# Interoffice Memo

**Subject:** Magnuson Apartments – Additional Drawing Information

The Petitioner has submitted additional drawing information in advance of the November 18, 2021 Plan Commission consideration of the Residence at Brookside Glen / Magnuson Apartments – Special use for a PUD Substantial Deviation. The drawings were dated November 12, 2021 and received November 15, 2021. The additional drawing information includes updated sheets as well as newly submitted drawing sheets. The updated sheets consist of the building elevations (four sheets). The newly submitted drawing sheets show the currently proposed site plan, sheds/terraces, and cabanas near the pool.

A-102

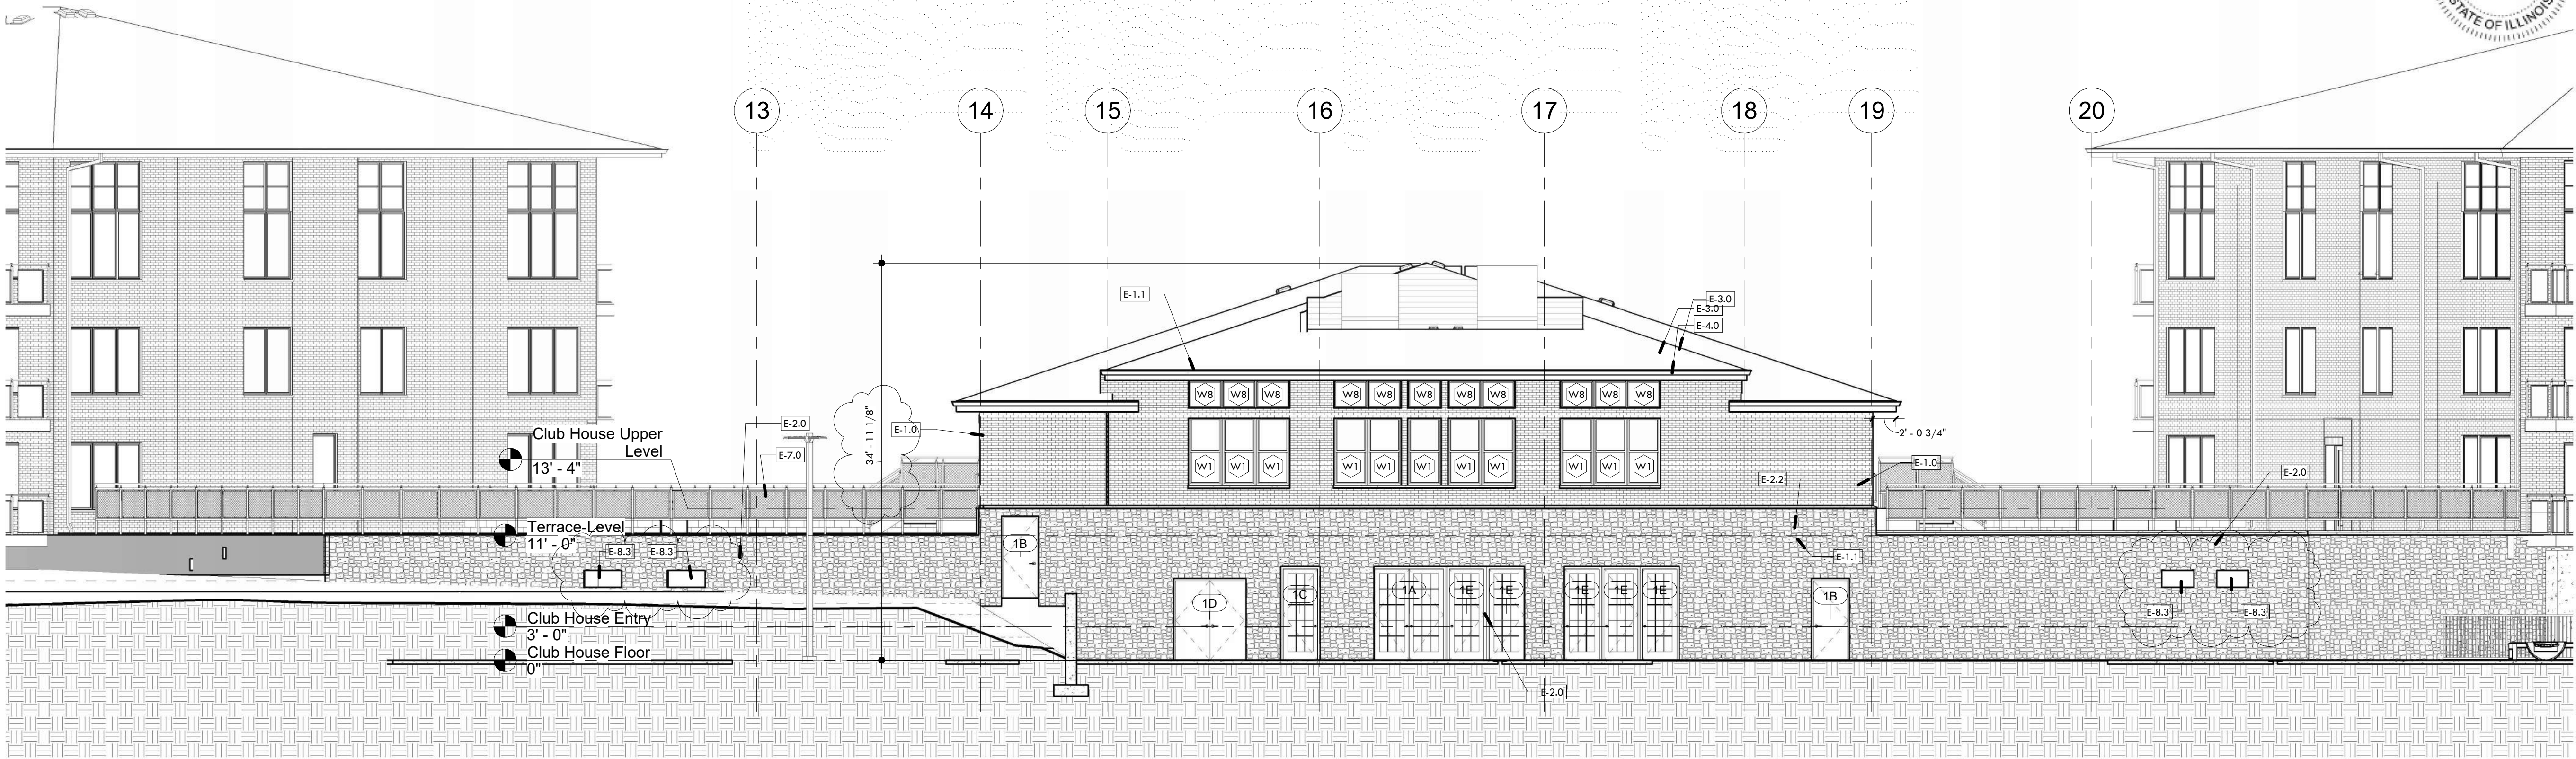
- (updated) Building One & Club House Elevations A-100, A-101, A-102, A-103
  - Residential east (front street-facing) entry canopy piers now are brick (not stone) with a 6" high stone accent strip

- A-100 & A-101 legends now list HardieBoard lap siding (was previously missing)
  - Drew in missing stone hatching on club house sides
  - Additionally, Staff notes the club house eaves are 2'-0 ¾", not the 4'-0" eaves as on the residential buildings
